HORSHAM DISTRICT COUNCIL CONSULTATION

TO:	Horsham District Council – Planning Dept
LOCATION:	Woodfords Shipley Road Southwater West Sussex
DESCRIPTION:	Application for Approval of Details Reserved by Condition 3 to approved application DC/25/1658
REFERENCE:	DISC/26/0167
RE-CONSULTATION:	1 st set of comments in black 2 nd set of comments in blue
RECOMMENDATION:	More Information / Modification

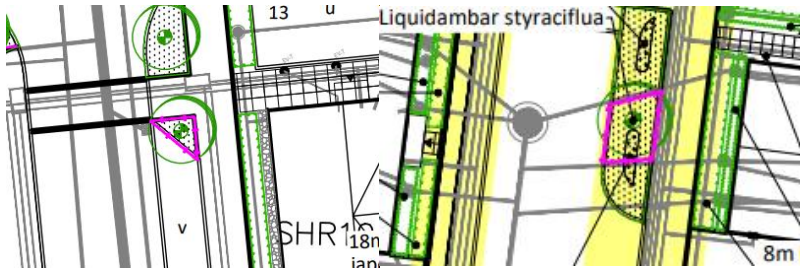
The current scheme demonstrates conflict between proposed tree planting, easement zones and utility corridor runs. See examples in purple below, which are not exhaustive.

Levels Plan
DC/25/1658

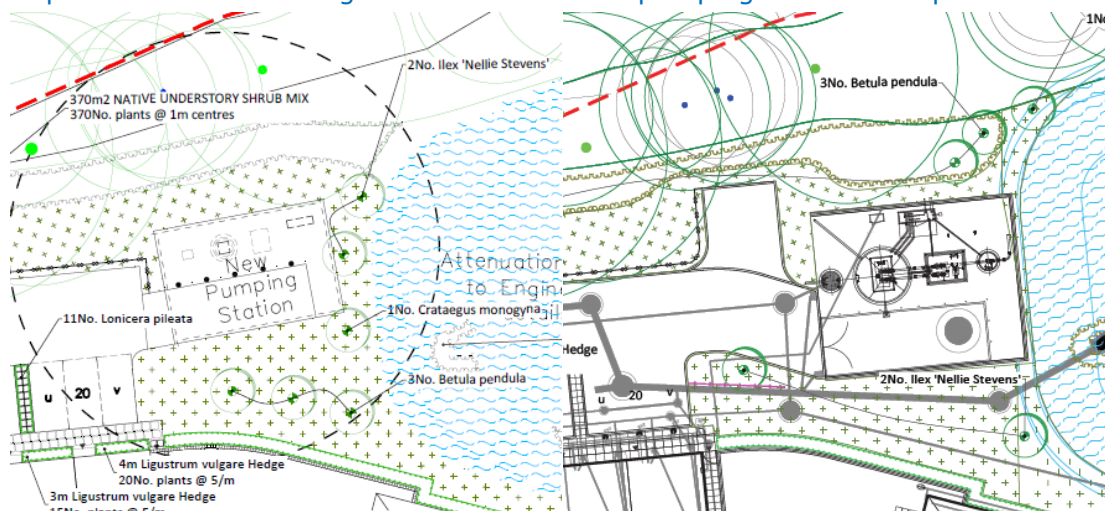
- In any case, the levels strategy needs to be reviewed and revised to demonstrate how the play area can be accommodated without unacceptable incursions within the RPAs of retained trees. For example, the extract from the levels plan below (submitted under DC/25/1658) suggests that the banking would result in a greater level of encroachment than would normally be acceptable under the principles of BS 5837, putting the long term retention of the trees at risk. See plans below:
